## Facilities Permit Plan Intake Form

Building Permit # 19-251956-REV-1 FA

Project Building Name / # Lloyd Center Tower - Suite 1145 - Workplace Resource Oregon

Project Name and Description Permit revision drawings for 19-251956-FA. Revision consists of revised lighting layout and deletion of tenant-supplied deferred submittal for demountable wall tracks. All demountable wall scope deleted.

## 8 DEMOUNTABLE WALL HEAD

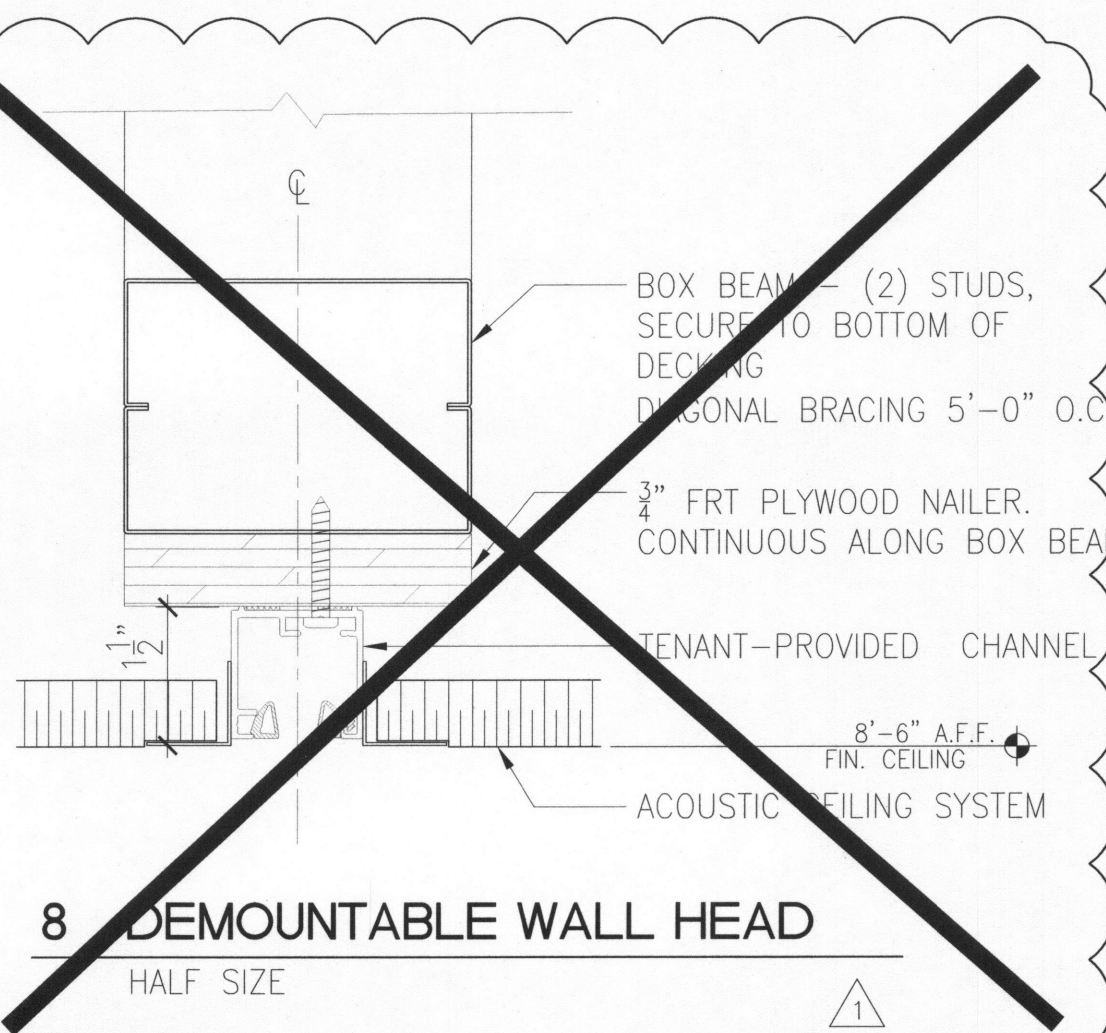
~~DEMOUNTABLE PARTITIONS (MAJOR WALLS)~~
